**BROWNS FERRY NUCLEAR PLANT (BFN) - UNITS 1, 2, AND 3 -
TECHNICAL SPECIFICATIONS (TS) CHANGES TS-431 AND TS-418 -
EXTENDED POWER UPRATE (EPU) - RESPONSE TO ROUND 13 REQUEST
FOR ADDITIONAL INFORMATION (RAI) - SBWB RAIs (TAC NOS.
MC5262, MC5263, AND MC5264)**

ENCLOSURE 2
TENNESSEE VALLEY AUTHORITY
BROWNS FERRY NUCLEAR PLANT (BFN)
UNITS 1, 2, and 3

RESPONSE TO ROUND 13 REQUEST FOR ADDITIONAL INFORMATION
SBWB ITEMS

Figure SBWB-82.4 Upper Plenum
Lower Collapsed Liquid Level for
0.05 FT2/PD MID SF-BATT 102P/105F EPU

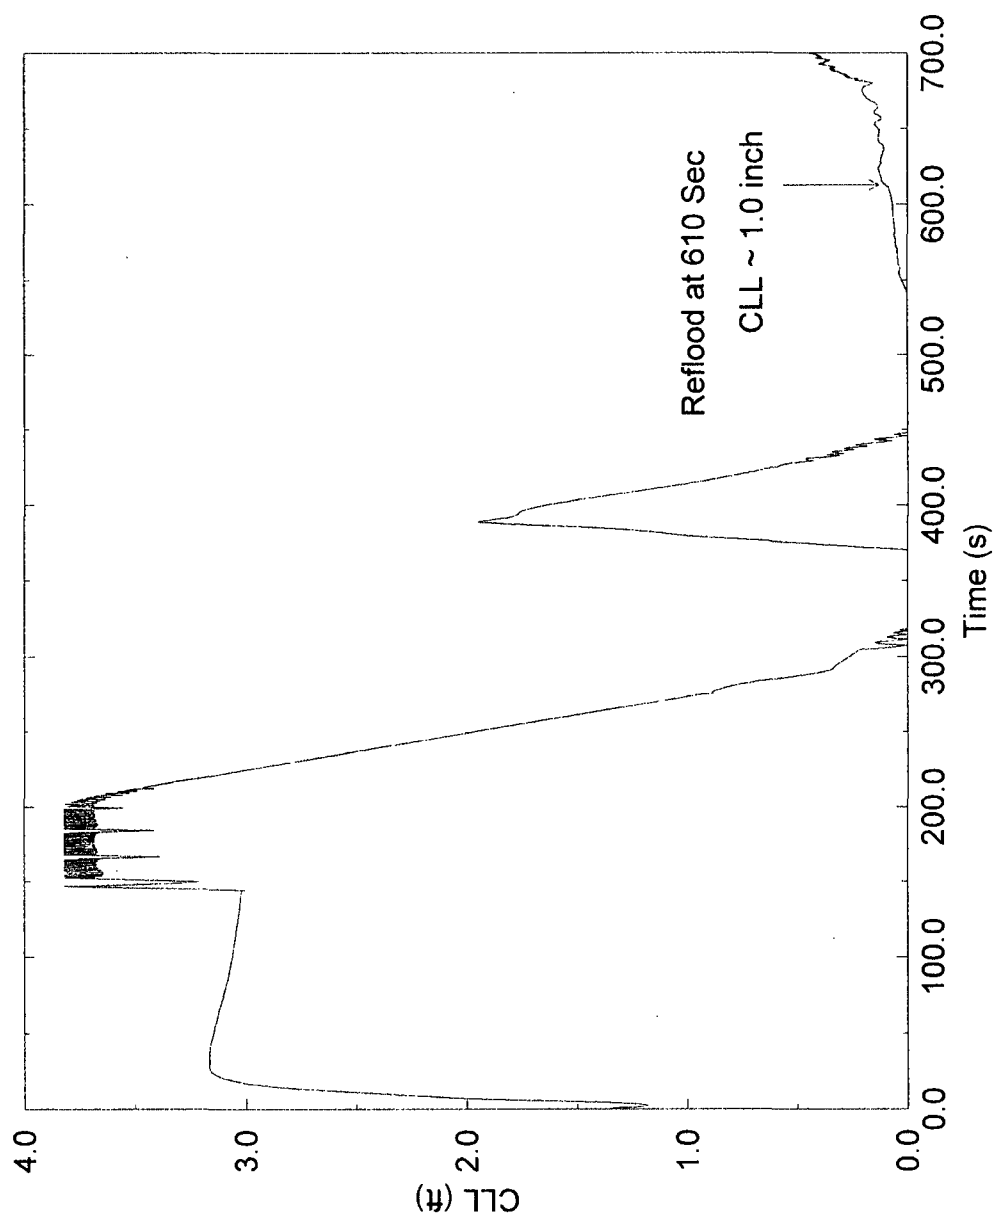
Provide the reference and/or description of the models governing counter-current flow (CCFL) at the exit to the hot bundle/core. Also identify the reference that describes the validation (separate effects and integral test data comparisons) of the CCFL limit model governing top down cooling in rod bundles.

Figures SBWB-82.4 and SBWB-82.5 show the collapsed liquid level (CLL) in the lower upper plenum volume (Volume 1) for the mid- and top-peaked 0.05 ft² breaks, respectively. As annotated, at the time of reflood the collapsed liquid level in Volume 1 is between about [] for these cases. Low pressure core spray (LPCS) is injected into Volume 1 and after LPCS injection begins there is no liquid water predicted to be in the upper upper plenum volume (Volume 2). Therefore, the data in these plots represent the CLL for the entire upper plenum region during the period of LPCS injection.

The reason so little water is retained in the upper plenum is because of the large bypass outlet flow area open to the upper plenum present in BWR-4 cores. The bypass exit includes the many open partial grids around the core periphery. In fact, the flow area of the bypass exit is more than half that of the combined fuel channels. There is not enough LPCS injection prior to reflood to fill the bypass so water injected in the upper plenum quickly drains into the bypass region for the entire LPCS injection period prior to reflood. As shown in Figures SBWB-82.6 and SBWB-82.7, the flow of liquid from the upper plenum into the bypass increases rapidly after the core spray begins which prevents substantial accumulation of water in the upper plenum prior to reflood.

Figure SBWB-83.1 Liquid Superficial Velocity at
Hot Channel Outlet and
Top Partial Length Rod Junction for
0.05 FT2/PD MID SF-BATT 102P/105F EPU

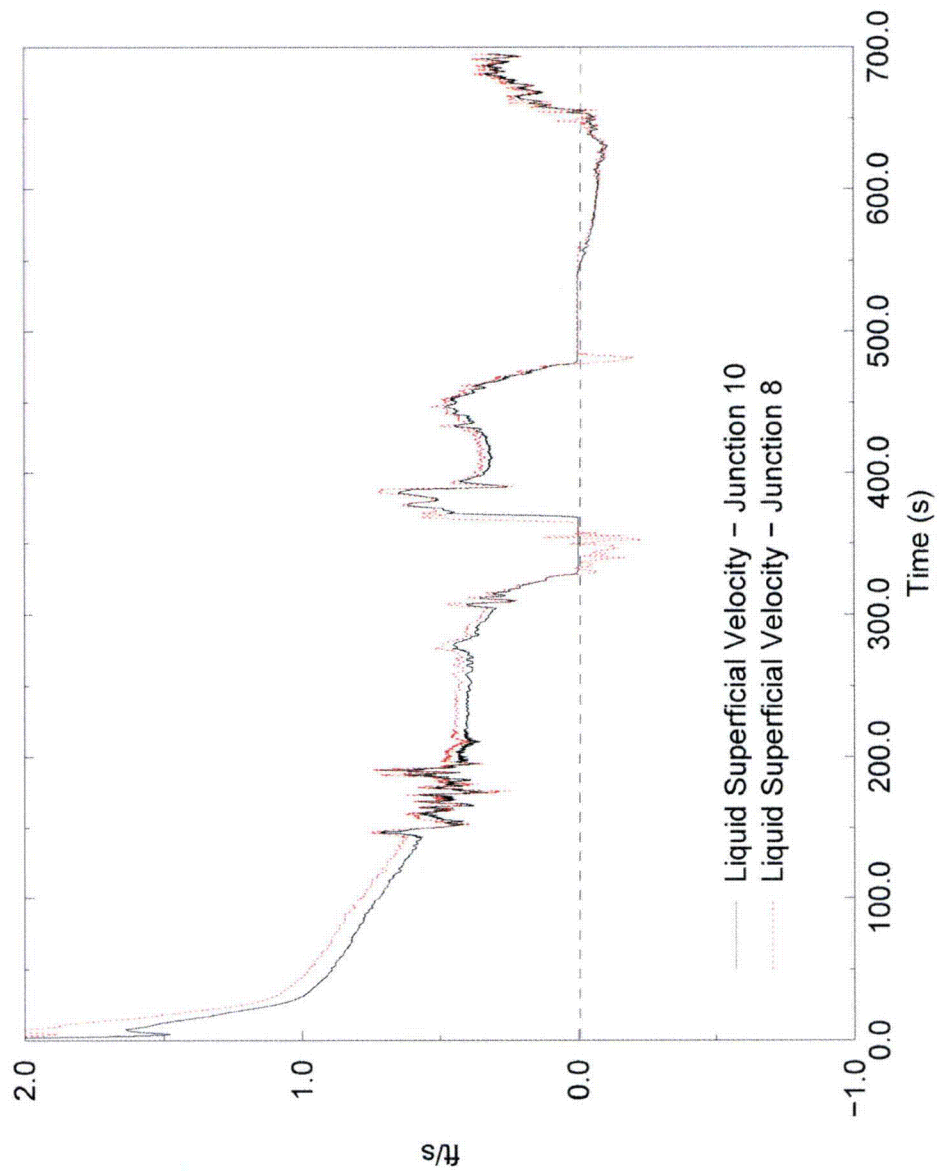
Provide the vapor and liquid hot bundle exit velocities versus time for the 0.05 ft² breaks presented in the April 18, 2007, SBWB-64 Supplement response.

The 0.05 ft² break vapor and liquid superficial velocities at the core exit junction for the hot bundle (junction 10 of Figures SBWB-83.5 and SBWB-83.6) are provided in Figures SBWB-83.1 through SBWB-83.4. The definition of superficial velocity used here is the velocity an individual phase would have if the entire flow region were filled with the selected phase at the predicted volumetric flow rate for that phase.

The flow area for the region of the fuel bundle with partial length rods is more restrictive for CCFL than the upper tie plate. So, the superficial velocities for the top hot channel junction with partial length rods from the mid-peaked analysis (junction 8 of Figures SBWB-83.5) are also provided. Flow at this junction for the top-peaked case is not provided because the partial length rods are below the peak power node. Therefore, CCFL at this junction is not relevant to countercurrent flow reaching the high power node for the top-peaked case. To provide a reference for the location of the junctions associated with the plotted data, the hot bundle nodalizations used in the RELAX model for mid- and top-peaked axial power peaking are presented in Figures SBWB-83.5 and SBWB-83.6.
